Rowe international, inc.

WBC-WBA Computer Board Changes

CONVERSION (COMPUTER BOARD)
FOR ROWE W.B.C.

HEADER CONFIGURATION FOR OLDER COMPUTER ASSEMBLY 6-50458-XX at P103

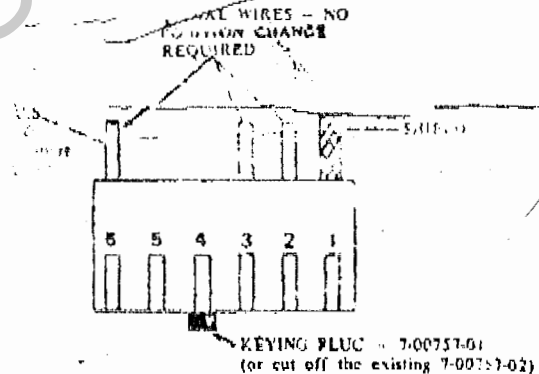
The boards are completely interchangeable with the following exception:

Connector pins 1 and 4 of P103 to the computer board are reversed, including keying plug. See figures 1 and 2 below.

The new part number is the 6-50528 series. Please note the similarity to the old part number 6-50458-01.
